COMMITTEE REPORT

PLANNING APPLICATIONS COMMITTEE: 26th April 2017

Address: Land at Madejski Stadium, Shooters Way

Proposal: Outline application for residential development (Blocks 1-6 only) to provide up to 422 residential units, comprising predominantly 1 and 2 bedroom apartments (Use Class C3) along with associated landscaping and car parking and application for residential and mixed use development comprising: 196 residential units, convention centre and ice rink, 246 bedroom hotel and up to 102 serviced apartments, decked car parking within convention centre, flexible ancillary retail space, multi storey car park, public open space, associated access, landscaping, cycle parking, transport interchange and related infrastructure/engineering works, ancillary facilities, access and demolition of existing indoor training facility and enhancement of existing RFC Garden of Remembrance.

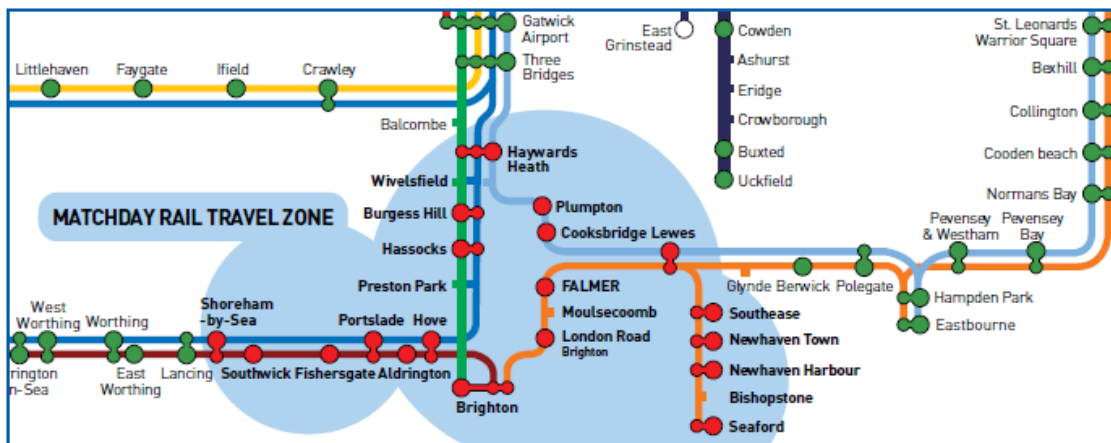
The interchange locates the bus storage area on the northern side of Northern Way with these vehicles being called to a specific stop on the southern side of Northern Way when a bus stop becomes available. As stated between paragraphs 2.5.5 and 2.5.8 there are a total of 21 bus routes consisting of shuttle services to Reading Station, Mere oak Park and Ride and Shinfield Park Park and Ride as well as local services and those travelling to the wider area that currently serve the site on match days. Out of these services the current operation accommodates the simultaneous loading of approximately 39 buses excluding the park and ride shuttle services. This is only the existing provision and does not take account of any additional services that need to be provided for should the stadium expansion be fully built out. On reviewing the interchange arrangement

Figure 2-2 Cordon Model Area

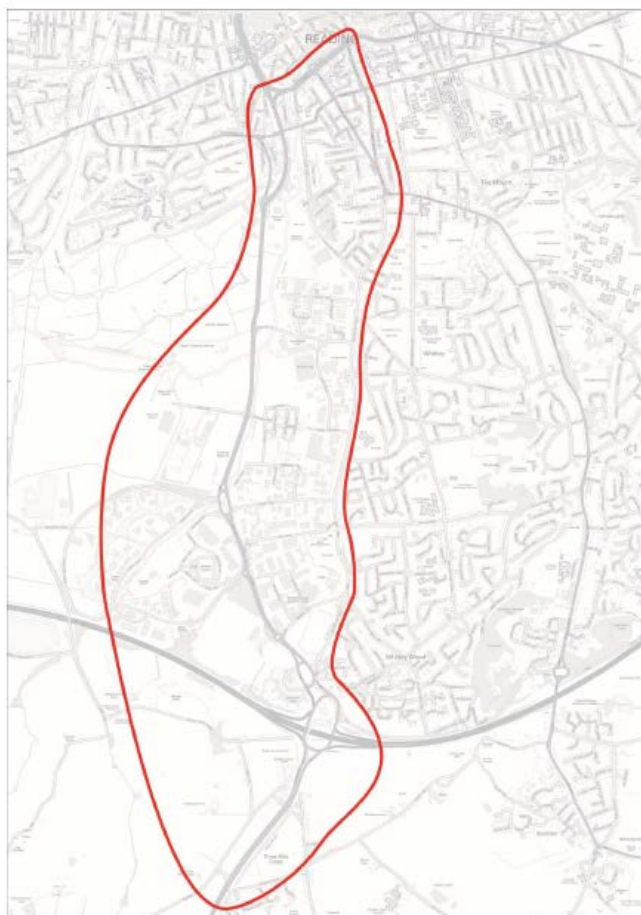
The committed developments in the area have been included within the assessment and the trips rates for these have been obtained from the relevant transport assessments (TA's) which is acceptable. TRICS data has also been used however it has not been demonstrated which developments TRICS data has been used and what the TRICS data is so that it can be agreed. This must be clarified to ensure that the background flows are acceptable.
